TO: Mayor and Council

FROM: Tom Crawford, City Administrator

SUBJECT: April 19, 2021 Council Agenda Responses

DATE: April 15, 2021

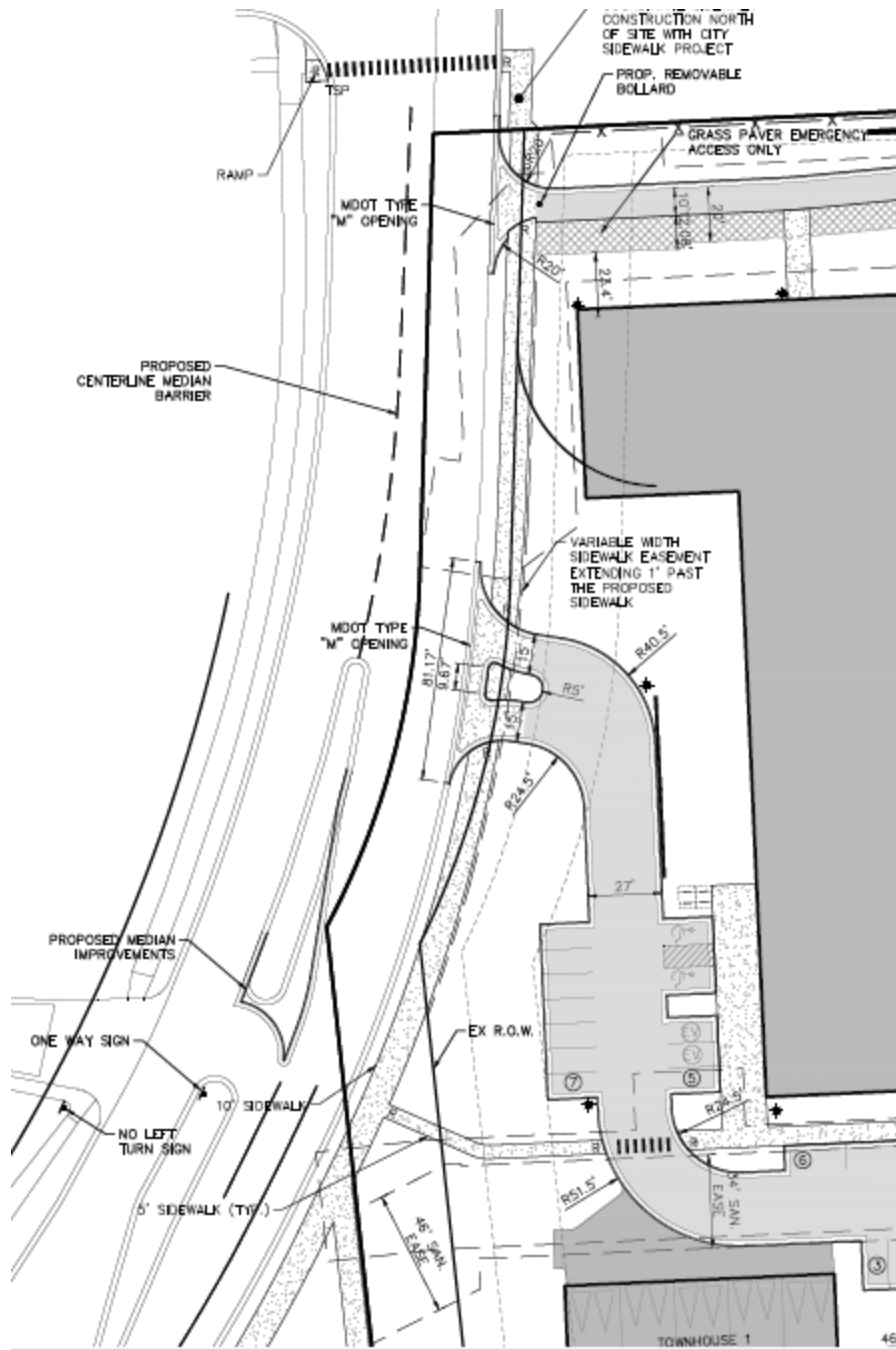
Question: Q4. I know that Council is not currently approving a site plan, but I would find it helpful to see a drawing of the proposed traffic mitigation--would that be possible? (Councilmember Disch)

Response: Yes. Please see below.
